PERCY-TERRY RESUBDIVISION

APPLICATION NUMBER 4 DATE December 17, 2015

REQUEST Subdivision

DETAIL SITE PLAN

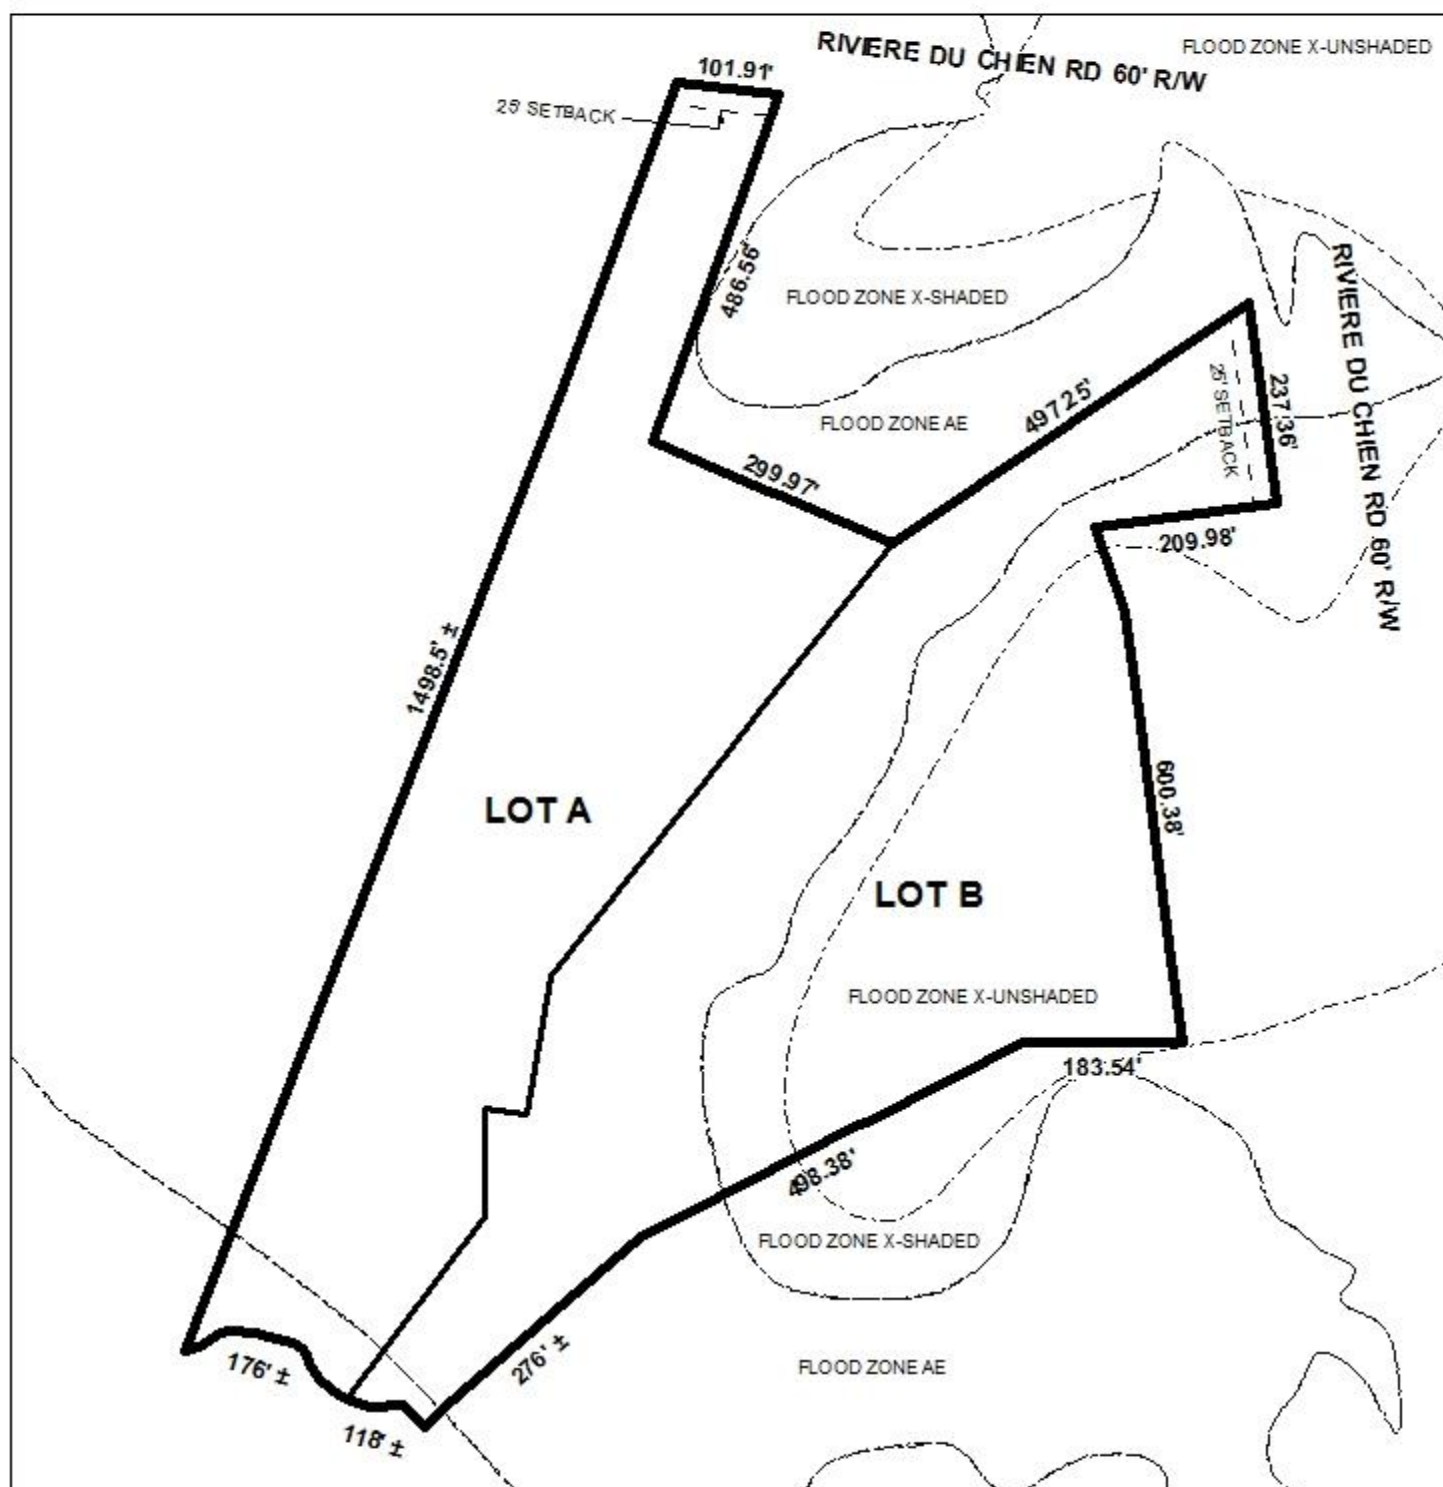
2. Review the written legal description to see if an additional bearing and distance should be inserted near the SE corner of LOT B between the end of the meanderings of the creek and the OTF (1/2" Open Top Pipe Found).

3. Review the need for a witness monument(s) along Halls Mill Creek and the channel up to the existing boat house.
4. Provide and label the monument set or found at the SE corner of LOT B, southwest of the OTF subdivision corner.

It should be noted that the proposed subdivision will result in an existing boat house crossing property lines. If approved, the boat house straddling this lot line must be moved to meet side and rear setback requirements. If the structure or lot line cannot be moved to comply with Zoning Ordinance setback requirements due to the geography of the tributary to which it is proximal, the boat house must be demolished.

- 4) adjustment of the lot line so the existing boat house complies with Zoning Ordinance setback requirements, or attainment of all necessary permits to either relocate or demolish the structure, prior to signing of the Final Plat;
